MEMORANDUM

DATE: April 29, 2020
TO: Newbury Zoning Board of Appeals
FROM: Ann M. Marton, Director of Ecological Services
RE: Comprehensive Permit Application and Site Plan Peer Review
 Village at Cricket Lane, Newbury, Massachusetts
LEC File#: ToNEW\17-300.02

VERNAL POOL DRAINAGE AREA - D SERIES WETLAND

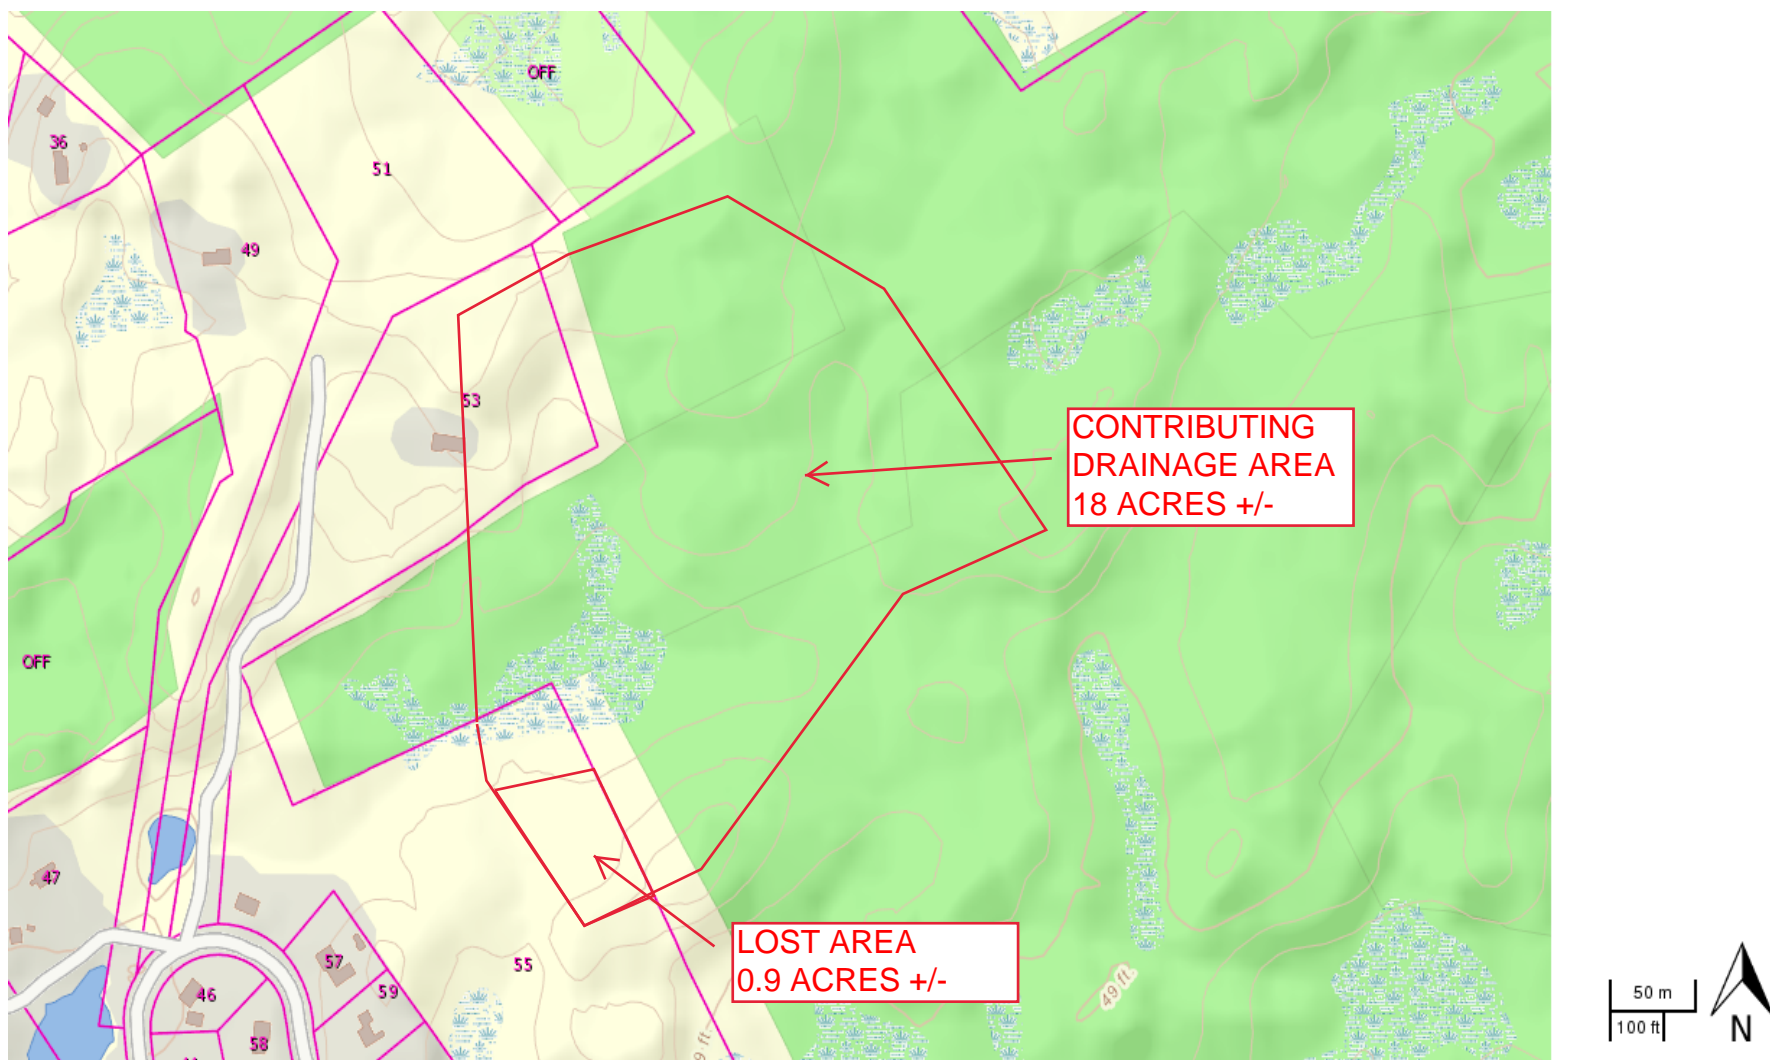
6. *Project Impacts to Vernal Pool Hydrology:* The project has been designed to balance pre- and post-development hydrology contributing to the vernal pools/wetland systems. The pre and post-development watersheds contributing to the two vernal pools was calculated by Ranger Engineering on Figures 3 and 4 attached. The vernal pool abutting state land in wetland D has an approximately 18 acre watershed and the project will reduce that contributing watershed area by .9 acres or 5%. This change occurs at the most downstream end of the wetland where the pool is located, where the change has the least potential for impact to the hydro-period of the pool. In addition, groundwater contributions from the immediately adjacent watershed are likely to be greater due to infiltration from the septic treatment areas, more than off-setting any change in the watershed area. All discharge from the septic system is presumed under Title V to be clean.

VERNAL POOL DRAINAGE AREA - A SERIES

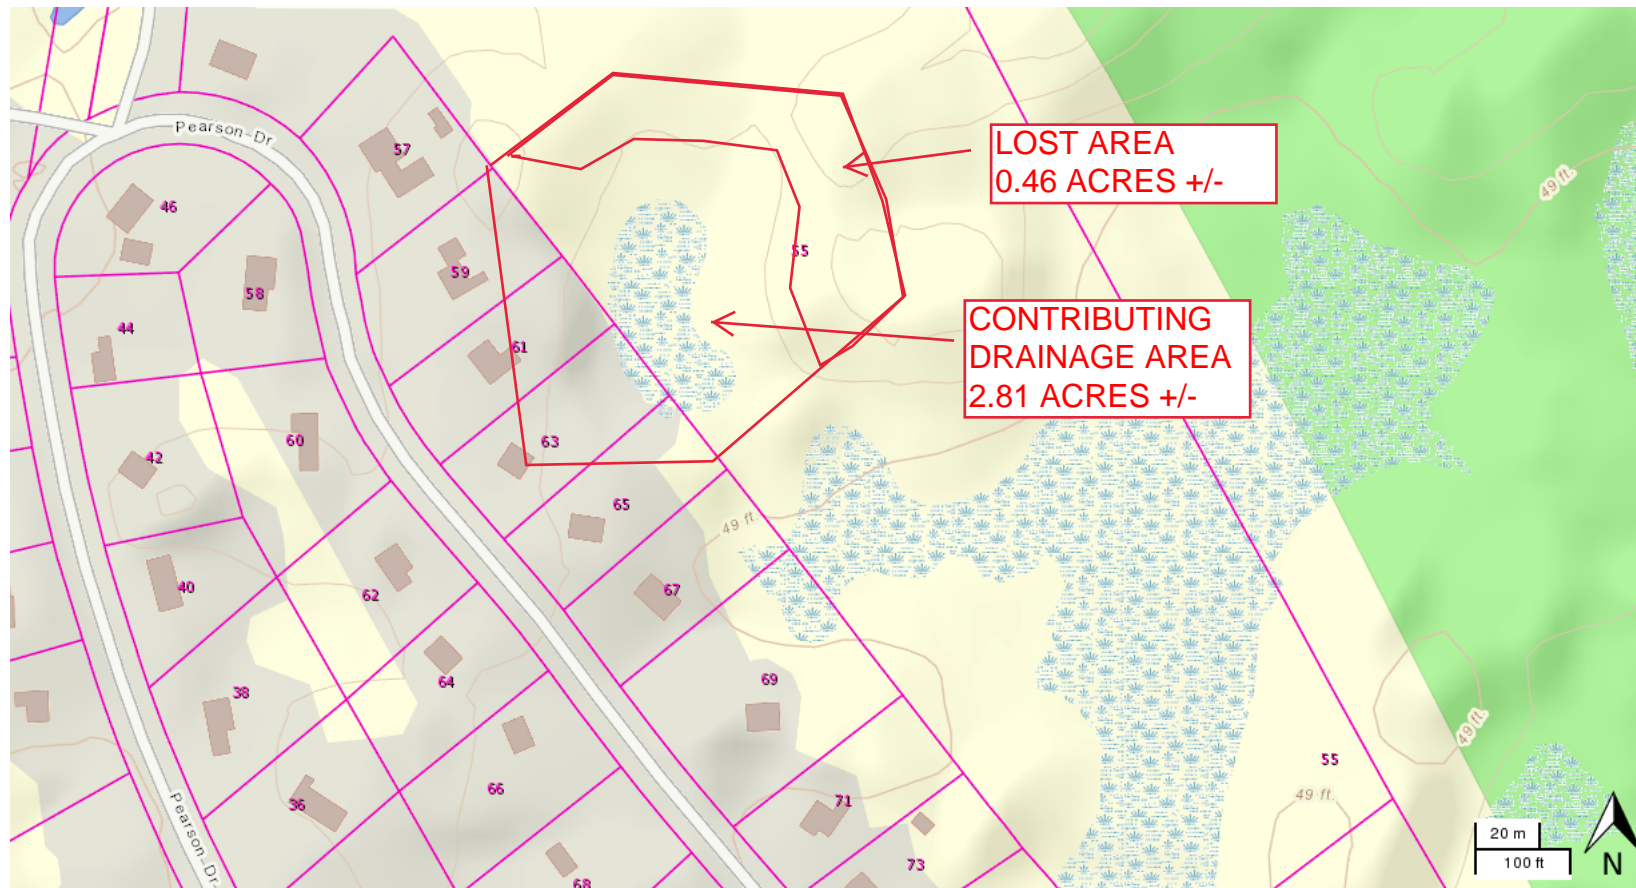
The contributing drainage area to the vernal pool in Wetland A is much smaller, at 2.81 acres. It is being reduced by 0.46 acres or 16%. Groundwater contributions are expected to be similar to existing conditions by infiltrating roof runoff in this area, resulting in no significant change to the hydrology of this pool.
